RE: Project #3028072-LU Zoning Review Cycle 2

Re: Project #3028072-LU

Correction Notice #2

RE: Project #3028072-LU Revegetation Review Cycle 3

A SITE SECTION
SCALE 1/16" = 1'-0"

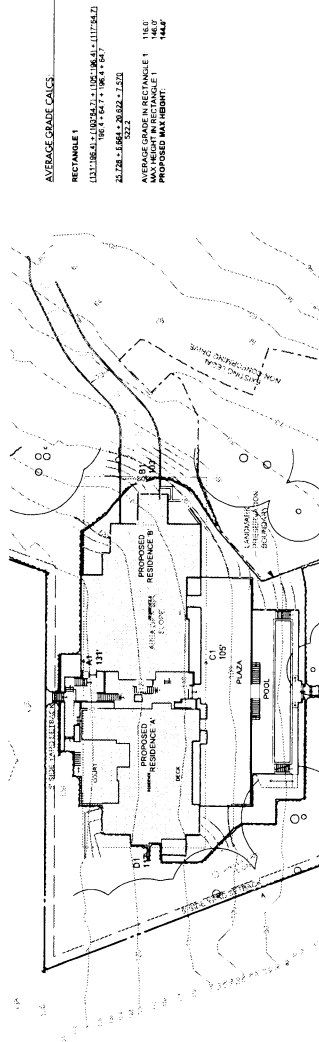
- 1) Parking garage has been adjusted to be completely below existing grade. Per agreement with SDCI email 2/11/2020, this will allow the houses to be considered as separate single family residences for zoning purposes.
